**CURATIVE AMMENDMENT FOR APPLICATION FOR
LICENSE (302-AM)**

WVOZ-AM AGUADILLA, PUERTO RICO

BL-20180911ADH (CP:BP-20170327AAF)

Changes made to EE -Proof of Performance:

Oct. 5/2018 (Curative Amendment)

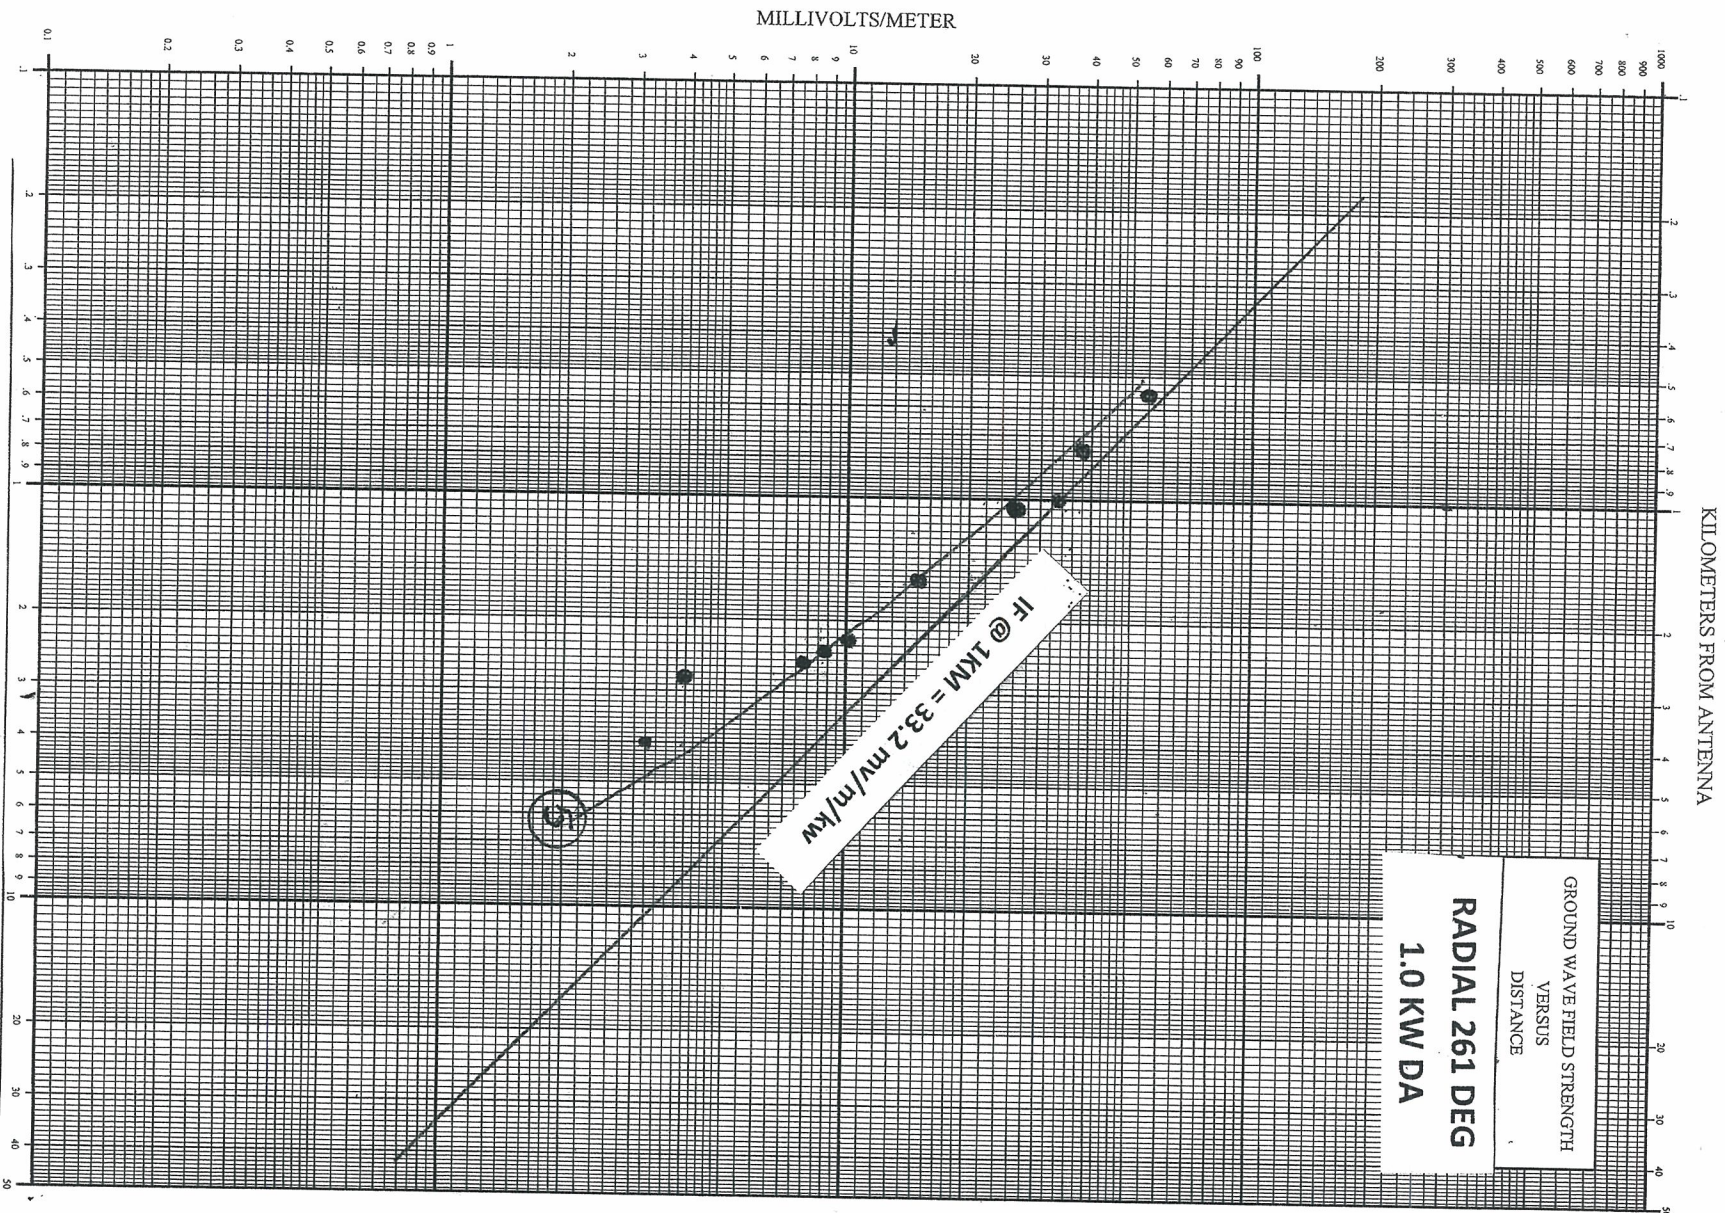
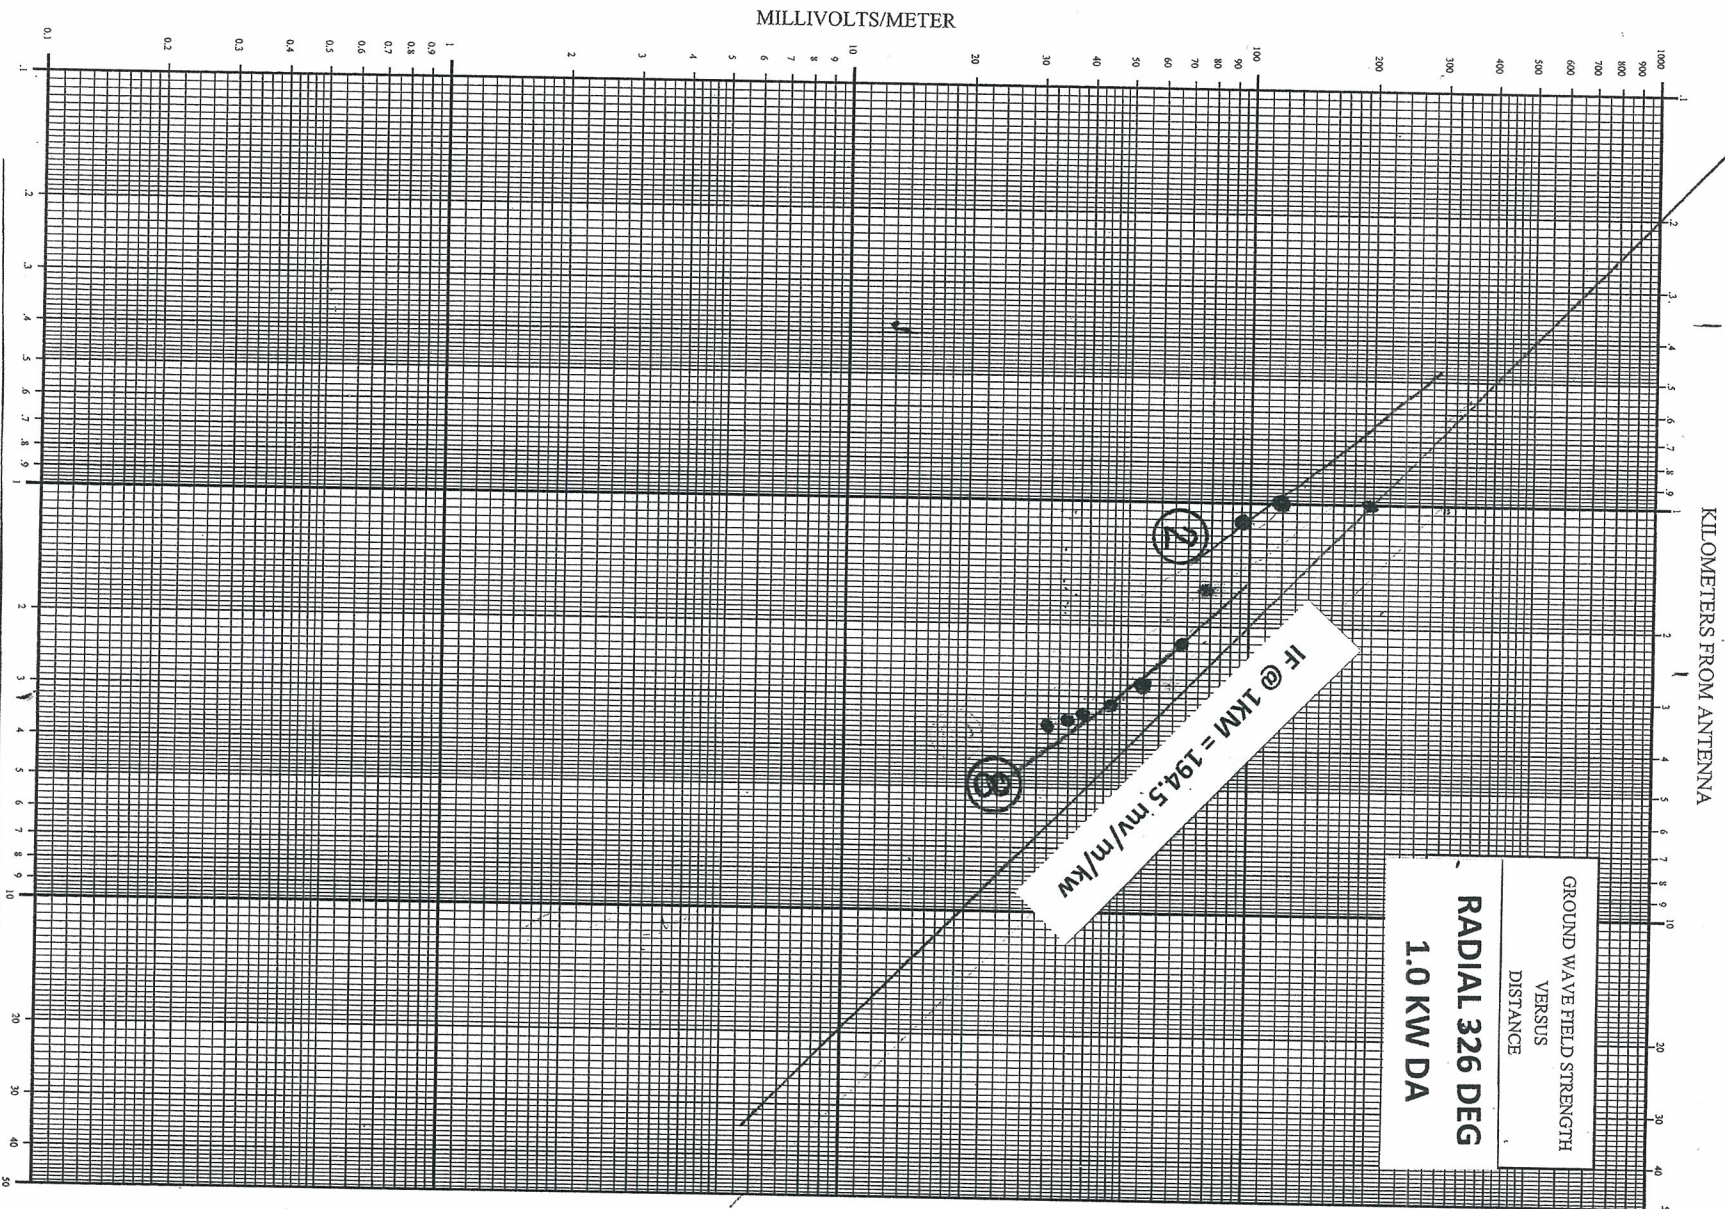
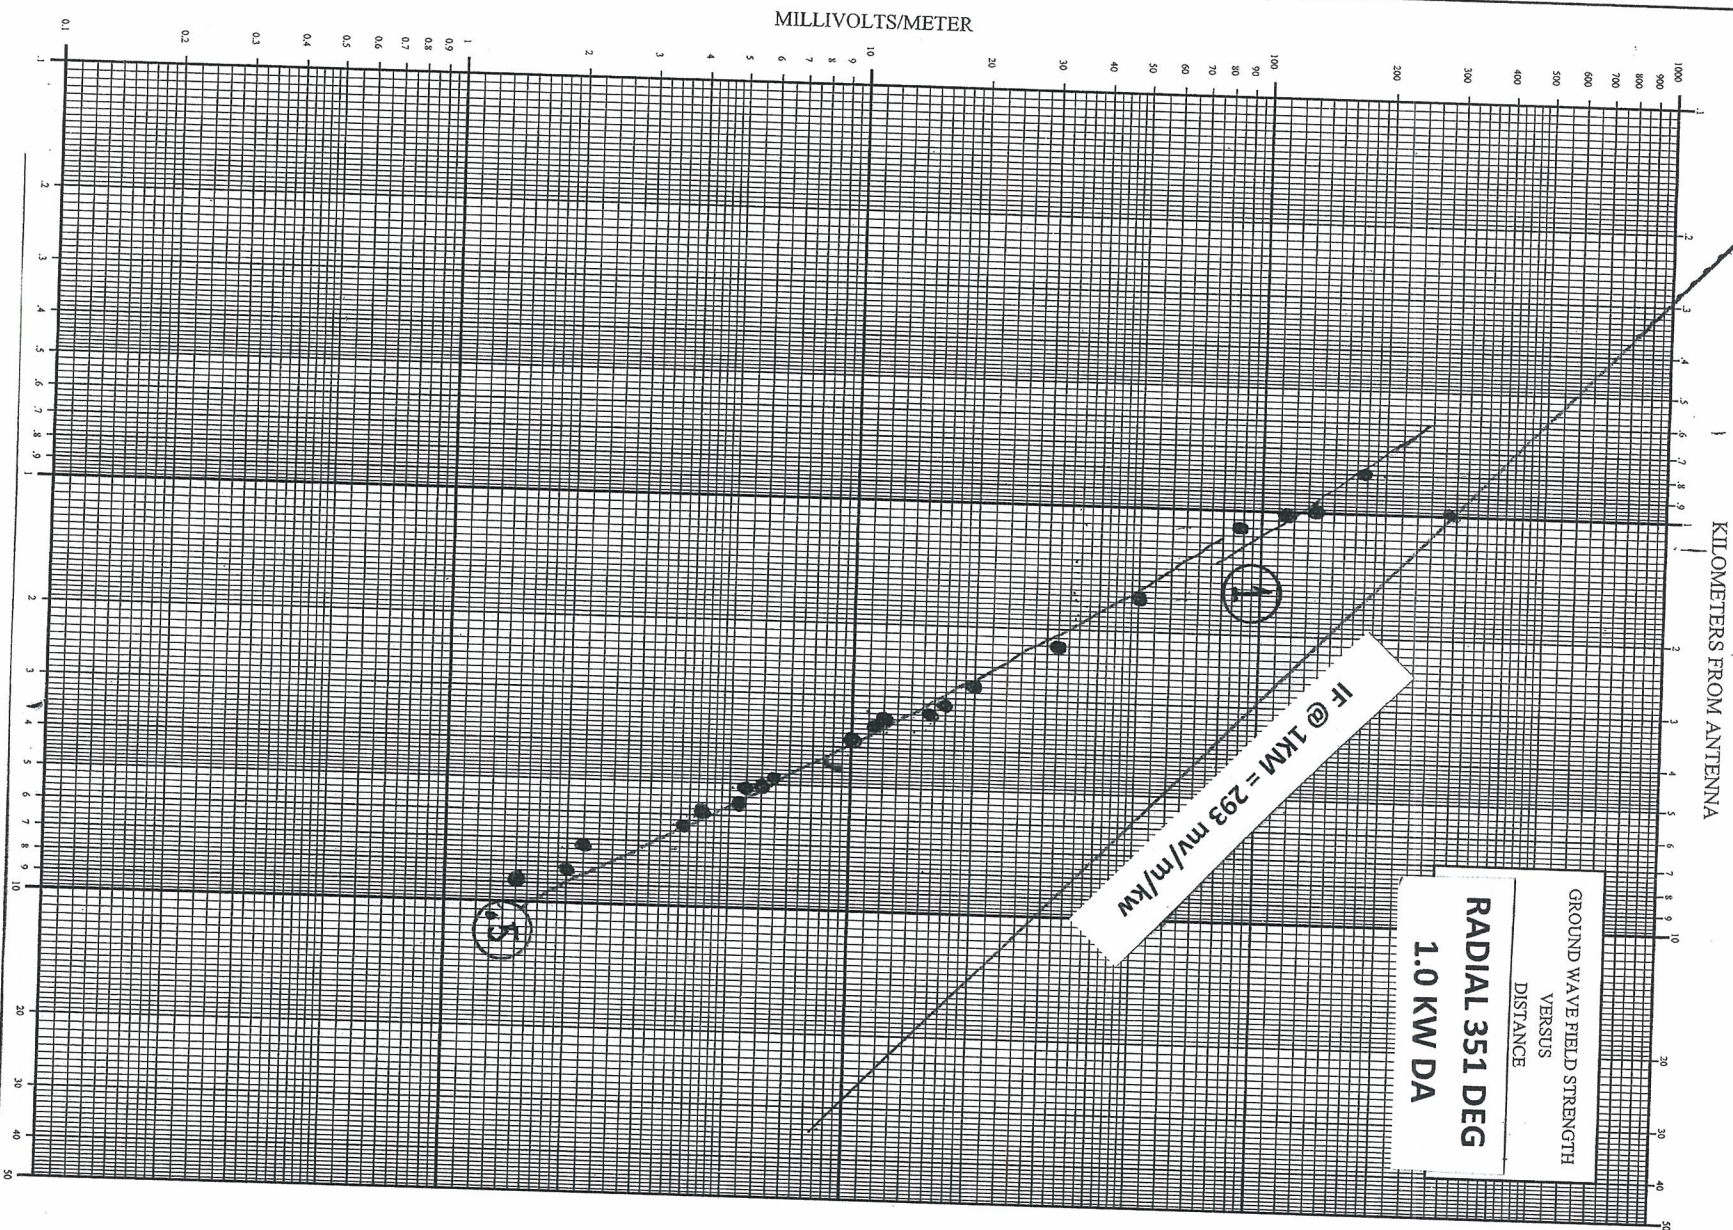
#1: By mistake, the secretary included as Figure 4 the incorrect set of graphs. The graphs that were included were an analysis tool and not the final graphs. The graphs incorrectly sent were used during the analysis process to figure out what the value for the points measured should most likely be after figuring out the attenuation curves by the best-fit method. That information was used to measure again most of the points that didn't fit on the conductivity curves selected for each radial to ensure the measurements originally taken were correct and that no error was made finding the correct point location and/or when taking the measurements.

The correct set of graphs is included for non-directional and directional. As you will see the conductivity curves chosen by the best-fit method are basically the same as the ones incorrectly sent. Although the email containing the PDF to the FCC was sent on Sept. 6/2018 and that same day the FCC emails back to us with the deficiencies, the paper filed copy was exactly the same as the one sent by email, since a curative amendment was immediately required by the FCC.

By this means, it is respectfully requested that the correct set of graphs along with the family of curves used to analyze them be made part of this curative amendment. (Please substitute the new set of graphs for each radial and insert Fig. 1 (Sheet 5A of 12: Family of curves for 1520-1600 downloaded from FCC page).
